Amdt. dated January 5, 2005

Reply to Office action of October 6, 2004

## Amendments to the Drawings:

OPENER FOR PULL TOP-TYPE CANS (Sheet with changes)

FIG.4

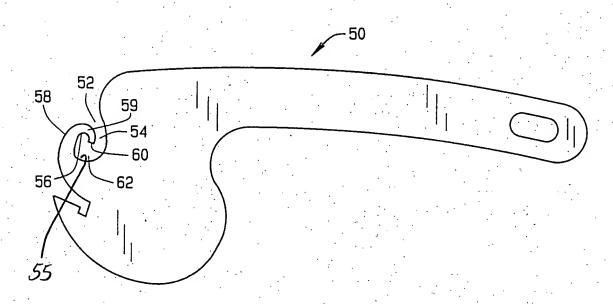
The amendments to the specification add reference numbers to FIGS. 4, 6

The attached two sheets of drawings includes changes to Figs. 4, 6 and 7. These sheets, which include Fig. 4-7, replaces the original sheets containing Figs. 4-7. Also attached are two sheets of drawings showing, in red ink, the changes made to FIGS. 4, 6 and 7.
